**EAGLE MOUNTAIN CITY**  
 City Council Staff Report

**JUNE 21, 2016**

*Project:* **Lakeview Estates**  
*Applicant:* Steve and Rod Allred  
*Request:* Preliminary Plat  
*Type of Action:* Action item

**PRELIMINARY UTILITY PLAN**

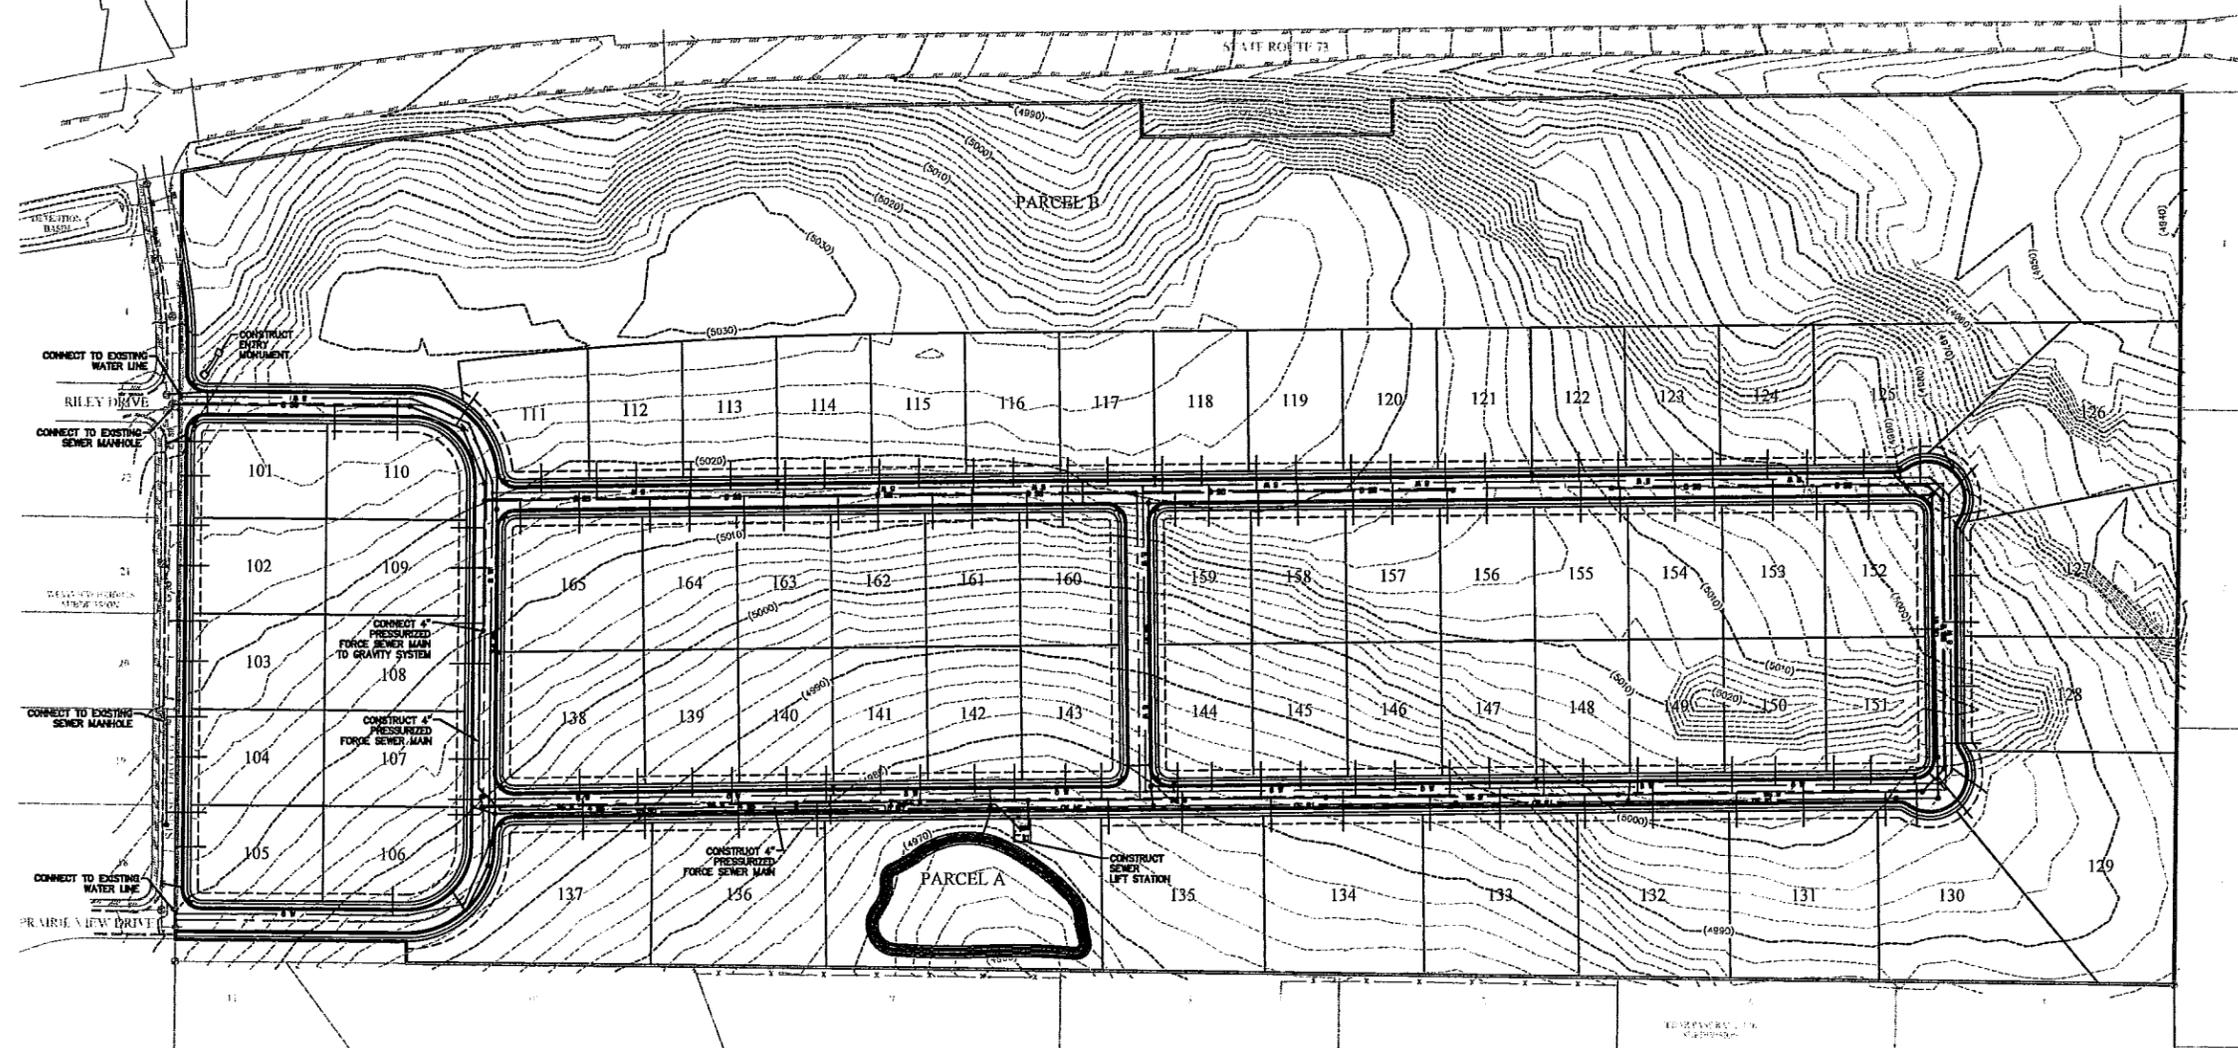
The applicant will need to submit a street light plan. The street lights can be added to the utility plan. The City will submit the plan to a third party to create an estimate of cost for the street lights. The applicant will pay the fee to the Planning department before the plat can be recorded. All lights will need to be dark sky compliant.

PRELIMINARY  
PLAT

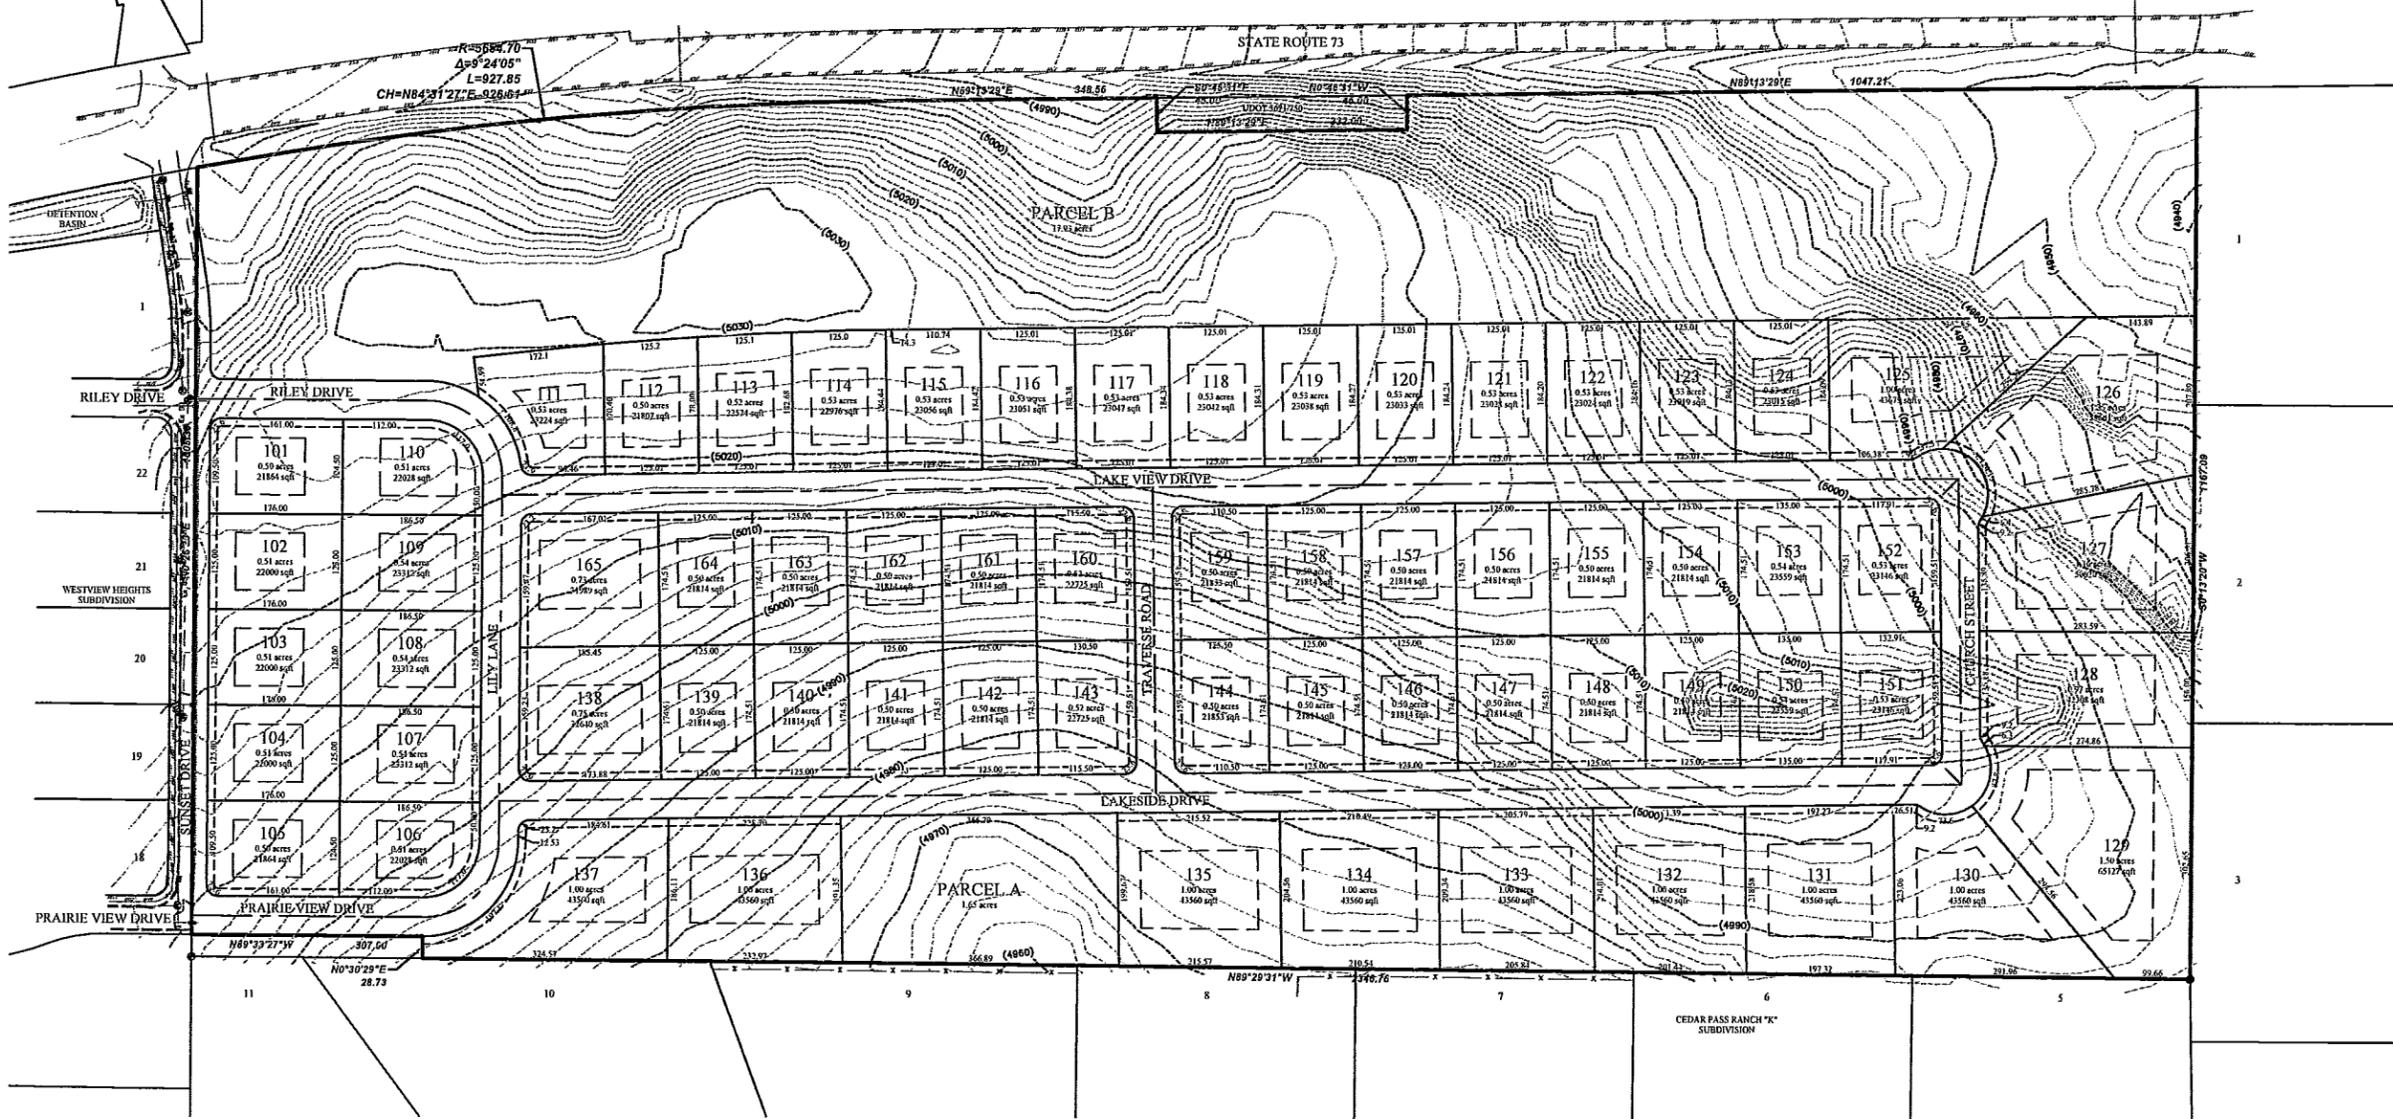
The applicant is proposing a preliminary plat consisting of 65 lots. The lots range from ½ acre to 1.5 acres in size. The density of the plat is 1.58 units per acre. The proposal does comply with the City’s Future Land Use General Plan. The General Plan land use designation for this area is Rural Residential which requires lots of a ½-acre minimum. This preliminary plat does comply with the buffering & transitioning requirements with the exception of Lot 128 it does not comply it is .97 ac should

be 1.0.

The proposed plat is showing a left over piece of property in the southwest corner of the plat. Staff feels that this piece should be incorporated into the proposed plat. The applicant can propose an alternative use for this piece. Staff is afraid that the piece would eventually end up in a tax sell with Utah County.

1. The applicant shall submit a parks and open space amenities worksheet.
2. Street lights are added to the utility plan.
3. The street names for Church Way and Lake View are changed.
4. Leftover piece of property in southwest corner of plat be incorporated in to the proposed plat or an alternative plan for the piece be approved.
